Issue date: 11-Sep-20
Revision date: N/A
Revision #: N/A

CIR #12 Detailed Summary

Please see attached CIR #12 for your review and response, for the Carleton Place Arena.

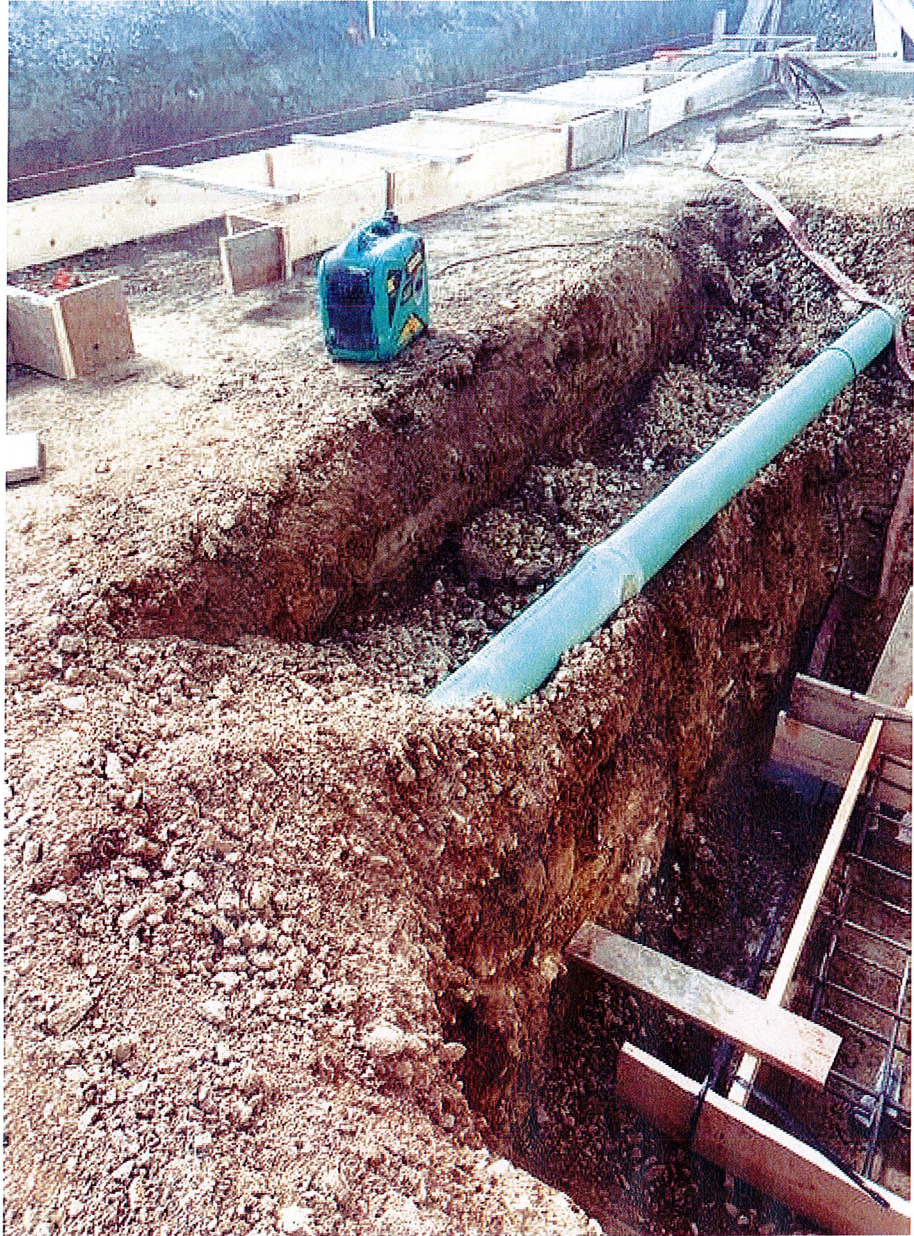
1. The required step footing on GL 2 connecting to the pier footing and required to be on undisturbed soil or bedrock, the distance of 10' between them does not allow to connect with the new storm sewer interfering. Attached marked up picture and pictures of site conditions for your reference below. Please provide instruction.

I have reviewed the photos and believe that the pipe can be sleeved through the wall. It is difficult to tell at this time if there will be a bar interference, however this can be addressed if that is the case using 4 diagonal bars (diamond shape) around the penetration. I would like to see how the bar layout goes and we can issue a sketch if that is the case. We need to maintain the required 2" clear cover from the pipe when doing this layout. Also you may want to consider sleeving the pipe if ever in the future you need to remove or replace this pipe.

The second consideration is that the backfill under this pipe will be very difficult to getting the necessary under slab compaction for. It has been my experience that to alleviate this issue the use of 0.4MPa flowable fill works very well. Should that product not be available a lean concrete mix of 4MPa can be used -though is not as economical as the flowable fill.

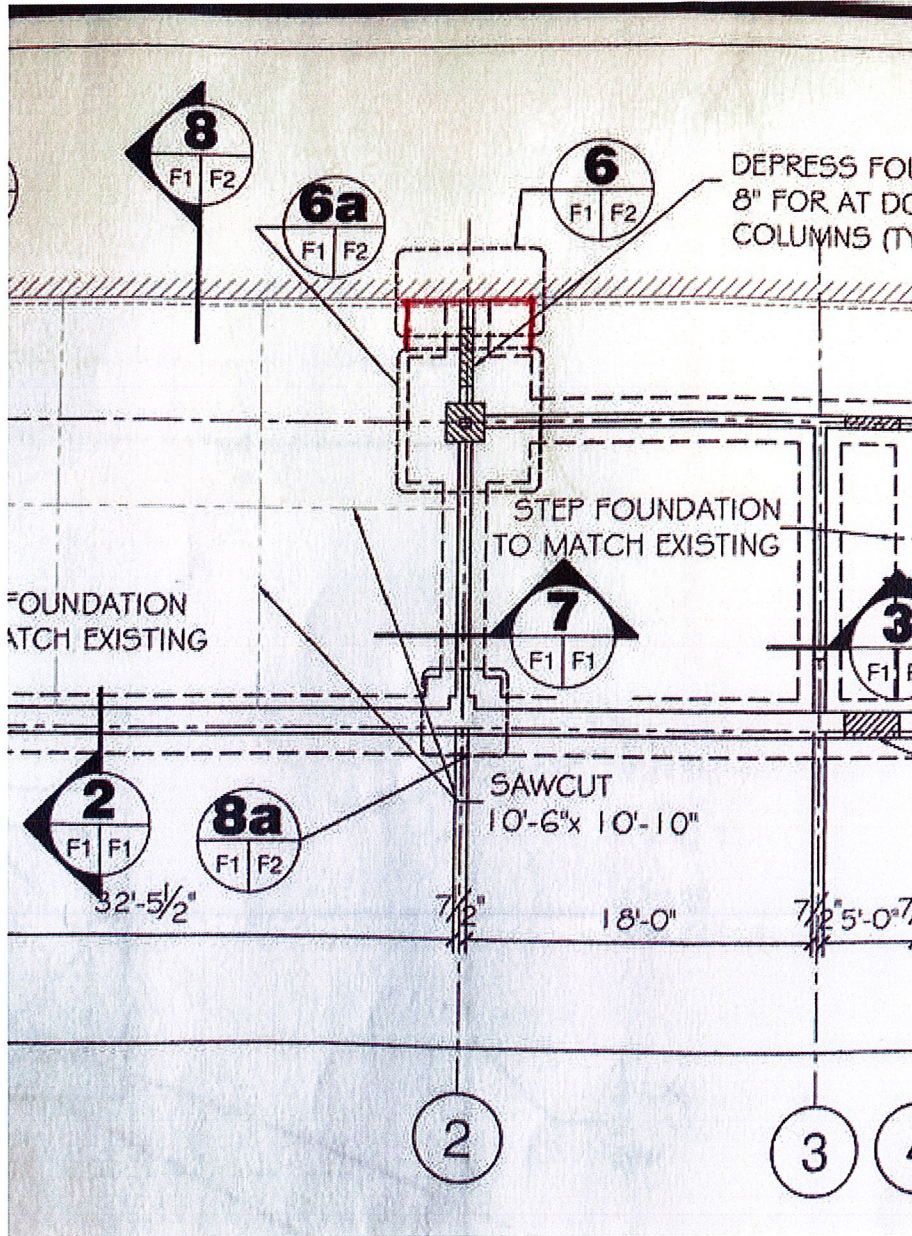
2. Please acknowledge the agreed upon plan with Eastern Engineering to proceed by attaching the full width of the footing 6'6" to existing footing and as the pier would be higher, the footing shall not be redesigned to carry the load; to maintain the 6'6" to one direction as is. Marked up picture in red below.
